## Peer Review File

Article Information: <https://dx.doi.org/10.21037/jss-23-93>

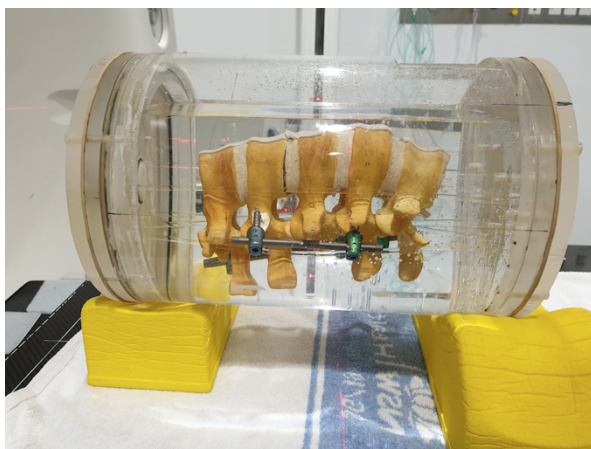
**Comment 4: Could you please render a picture of or explain about the configuration of experimental construct. Where was the crosslink bar placed, at the end or in the middle of the construct?**

**Reply:** Thank you for this suggestion. On repeat review of the methodology, a crosslink bar was not used in both experimental constructs. This has been removed in lines 205 – 206. Pictures of the experimental constructs have been included for reference as figures 3 and 4 in line 206, along with an explanatory caption starting on line 625. The previous figures 3 and 4 are now renamed 5 and 6.

(Page 5, Line 205) ...pedicles and 2 screws in the right pedicles – connected by 2 longitudinal rods made of the same material as the pedicle screws (figures 3 and 4).

**Figure 2. Digitized EBT3 film of titanium pedicle screw from a 6 MV beam at 10 mm depth.** The isocenter is indicated by the intersection of the yellow lines. The dotted lines in Figure 2B indicate dose profiles through the screw and tulip, as well as the longitudinal axis of the screw.

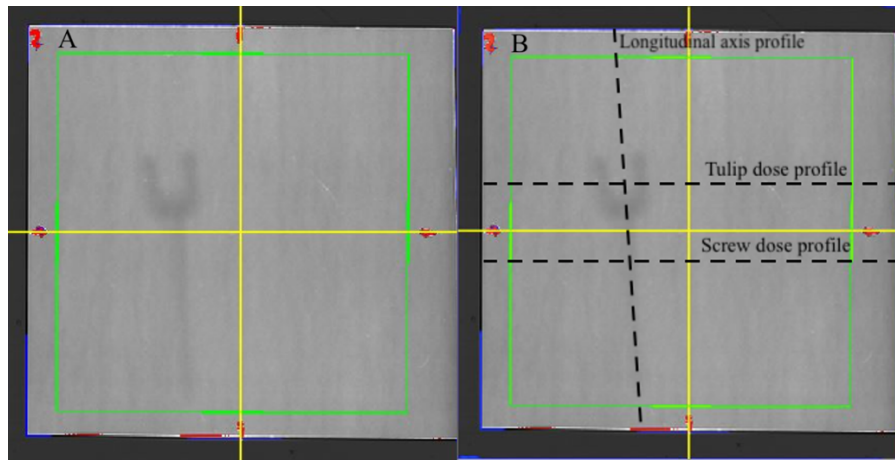
**Comment 9: Line 142-144: the passage needs to be better explained for the sake of clarity. The passage misses of a clear definition of the reference depth and the isocentre. Moreover, observing Figure 2, it is not clear where the screw dose profile must intercept the screw thread. Please provide further details.**

**Reply:** Thank you for this comment. Lines 178 - 180 attempt to describe the process of creating a calibration curve so that optical changes in the radiochromic films could be converted into a received radiation dose. This was achieved by delivering radiation that would be correspond to known doses (up to 200 cGy) received by the radiochromic films at a depth of 1.5 cm. Lines 178 - 180 have been rewritten to clarify this. Regarding figure 2, we realise that the outline of the screw and screw thread is not very clear when the axes for the profiles have been drawn. We have revised figure 2 to include the original picture without modifications, so that the intersection between the dose profile and screw thread is more clear.

(Page 5, Line 178) A dose calibration curve of optical density change in the radiochromic film to received dose was created for the 6 MV beam by delivering known doses up to 200 cGy to the isocenters of separate EBT3 GafChromic™ films at a fixed depth of 1.5 cm (figure 2).

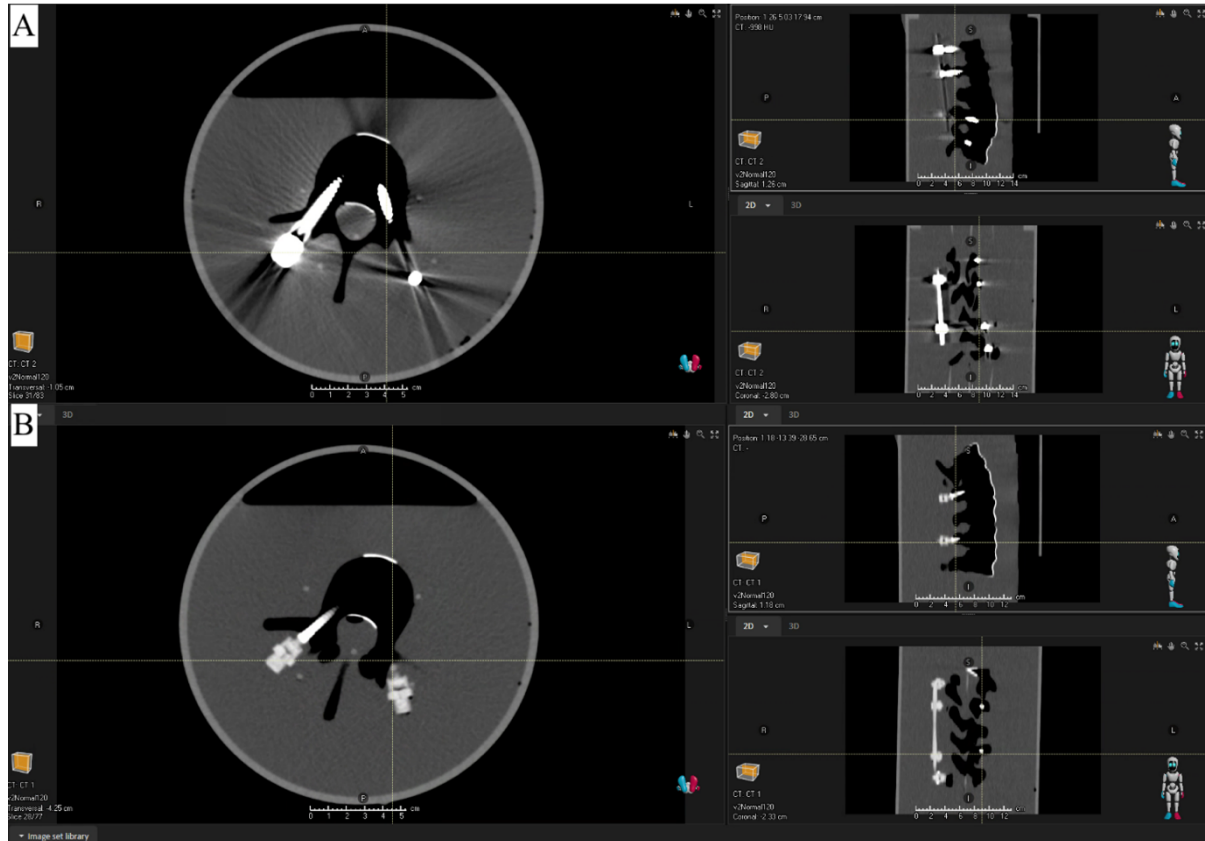
**Comment 2: Can the authors at least show vivid CTScan images of the artefacts created by CF/PEEK versus Titanium screws in their models.**

**Reply:** Thank you for this comment. An additional figure (described in line 414) has been included in the discussion to demonstrate the difference in artefacts generated on CT.

(Page 11, Line 414) ... and the tissue around the protruding tulips (see figure 7).
